SAG HARBOUR: 217
- MOVE FRONT DOOR (FOR 6" WALL BEHIND WASHER/ DRYER)

SUITE 217. SAG HART R.

■ HAMPTON PLACE ■ 25 Baker Hill Bldg
Jaffrey, ON ■ Jan 23, 2018
DRAWING AS PER AGREEMENT OF PURCHASE AND SALE (before decor appointment)

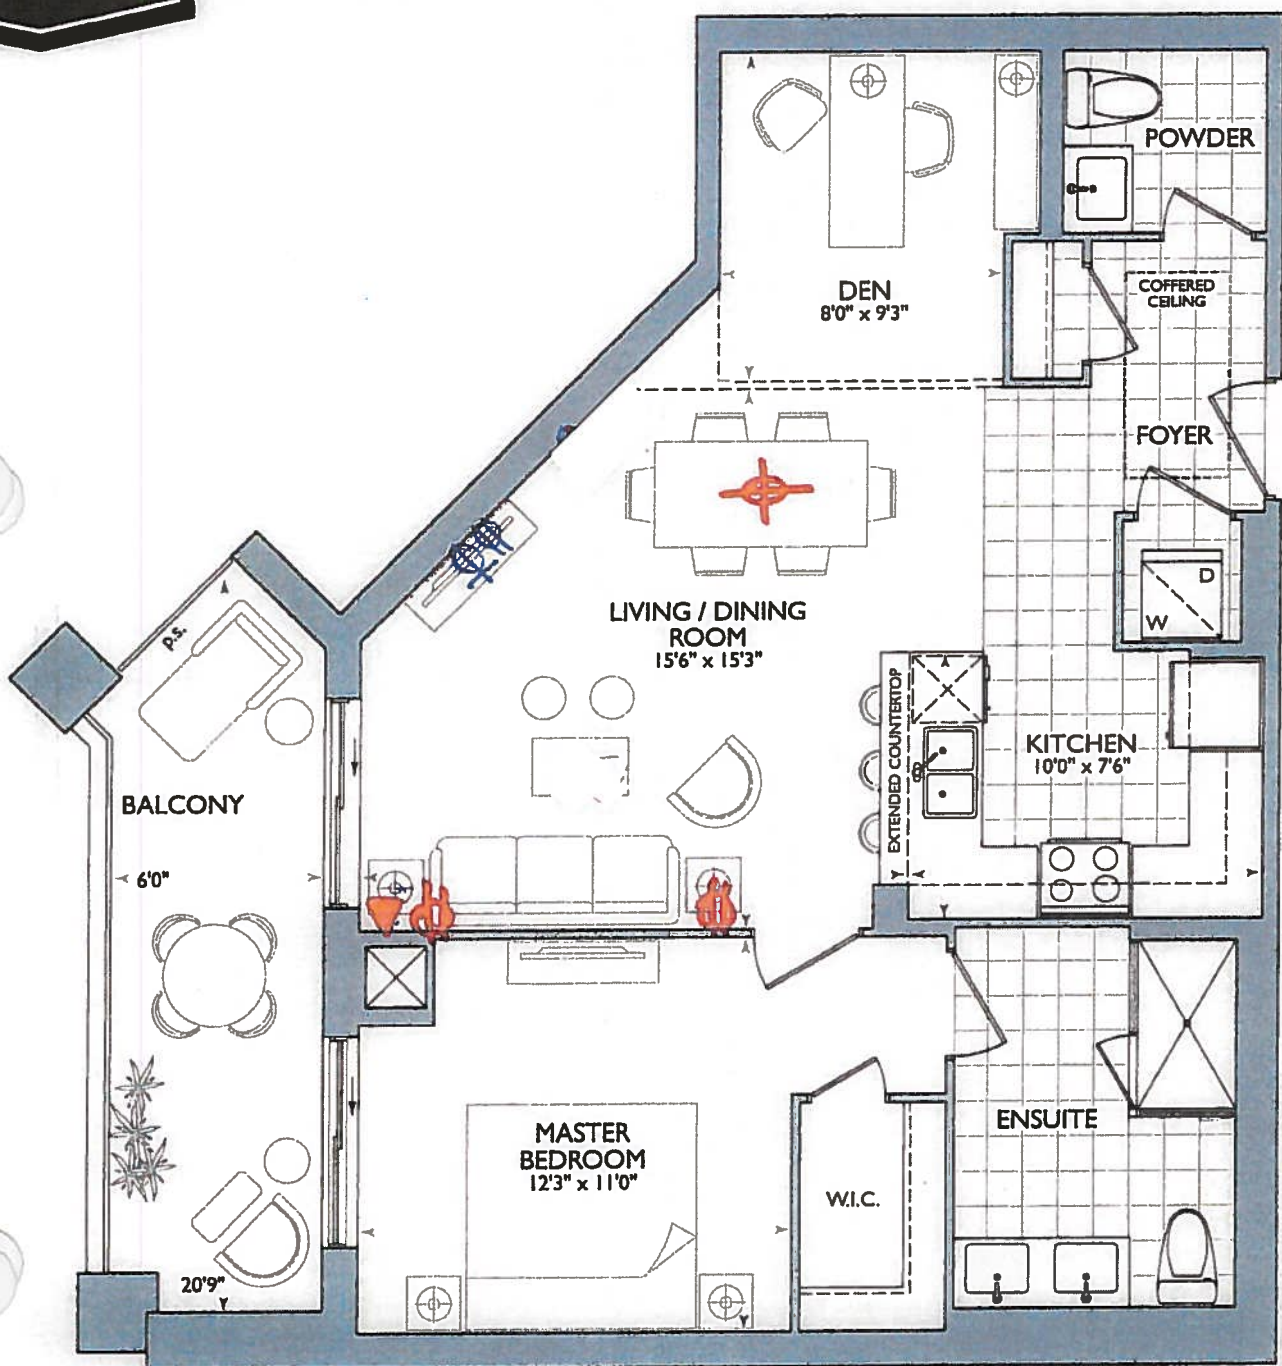
*Front Door move *
Due to Laundry Room
Kitchen size .
